World Forum for Harmonization of Vehicle Regulations

153rd session

Proposal for the 01 series of amendments to Regulation No. 43 (Safety glazing)

Submitted by the Working Party on General Safety Provisions*

"Figure 1

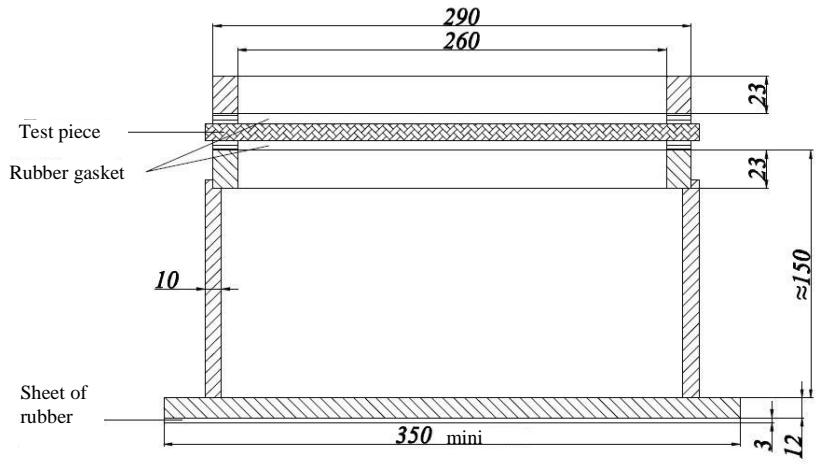
Paragraph 2.1.1.3, figure 1, amend to read:

Support for ball tests

"Figure 20
Sample

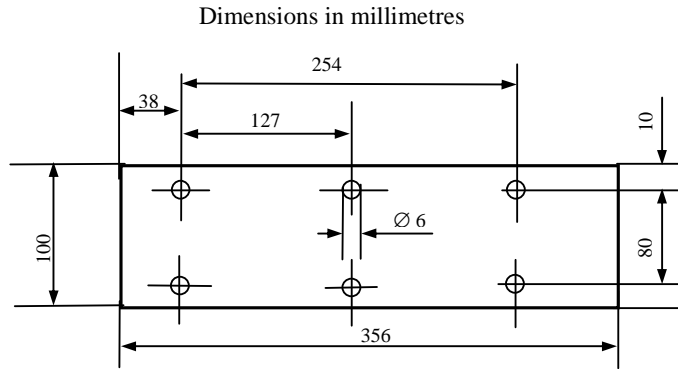
Paragraph 10.5.1., figure 20, amend to read:

"Figure 3

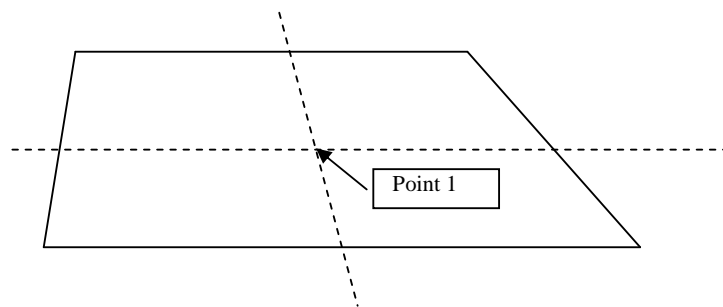
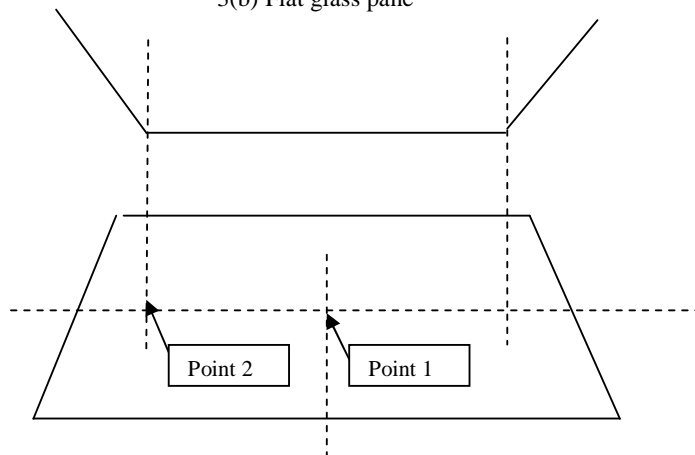
Annex 17, figure 3, amend to read:

Prescribed points of impact for uniformly toughened glass panes

3(a) Flat glass pane

3(b) Flat glass pane

3(c) Curved glass pane
